# Access Compliance Report

## Public Rights-of-Way

### (Curb Ramps)

Intersection ID: 51667	Main Street: HUCKS_RD	Cross Street: SWEETBRIAR RIDGE_DR	Location: W
ADA ID: D0EA1A5B715C	Ramp Type: BlendTrans1	Initial Pass/Fail: Fail	Overall Compliance: No
			Severity Score: 33.75

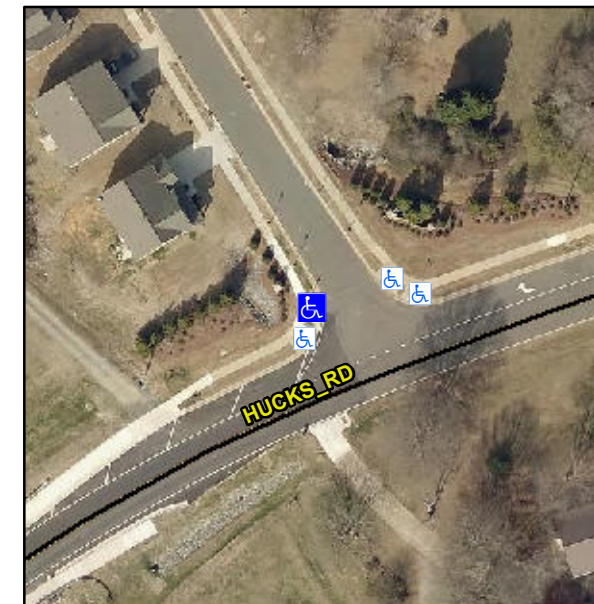
**CURB GAP 1.0**

**Not Found, R304.5.1, R304.5.3**

Compliance	Description	Data	Compliance	Description	Data
N/A	Ramp Length (in)	70.0	Yes	BlendTrans Slope (%)	2.7
No	Ramp Width (in)	47.0	No	BlendTrans XSlope (%)	8.6
N/A	Flare Type LT	N/A	N/A	Flare Type RT	N/A
N/A	Flare Slope LT (%)	N/A	N/A	Flare Slope RT (%)	N/A
N/A	Flare Traversable LT?	N/A	N/A	Flare Traversable RT?	N/A
N/A	Landing Length (in)	N/A	N/A	DWS Provided?	N/A
N/A	Landing Width (in)	N/A	N/A	DWS Contrast?	N/A
N/A	Landing Slope (%)	N/A	N/A	DWS Length (in)	N/A
N/A	Landing X Slope (%)	N/A	N/A	DWS Full Width?	N/A
N/A	Landing Curb? (Y/N)	N/A	N/A	DWS Offset (in)	N/A
N/A	Shared Landing?	N/A			
N/A	Gutter Ponding?	N/A	N/A	Gutter Slope (%)	N/A
N/A	Gutter Lip Ht (in)	N/A	N/A	Gutter X Slope (%)	N/A
N/A	Painted X Walk1?	No	N/A	Painted X Walk2?	N/A
	X Walk 1 Direction	To NE		X Walk 2 Direction	N/A
	X Walk 1 Width (in)	N/A		X Walk 2 Width (in)	N/A
	X Walk 1 Slope (%)	2.0		X Walk 2 Slope (%)	N/A
	X Walk 1 X Slope (%)	7.5		X Walk 2 X Slope (%)	N/A

N/A	Ramp inside XWalk1?	N/A	N/A	Ramp inside XWalk2?	N/A
	Road Slope (%)	7.5		Clear Space?	N/A
	Road X Slope (%)	2.0	N/A	Clear Space to XWalk (in)	N/A
N/A	Any Obstructions?	N/A	N/A	Storm Grate/Utility Hazard?	N/A
	Obstruction Type			Storm Grate/Utility Type	
		N/A			N/A
			Yes	Surface Condition? (G/P)	Good
			No	Curb Slope (%)	22.1

**Remove & Replace Curb Ramp With Two New Directional Ramps or Equivalent.**
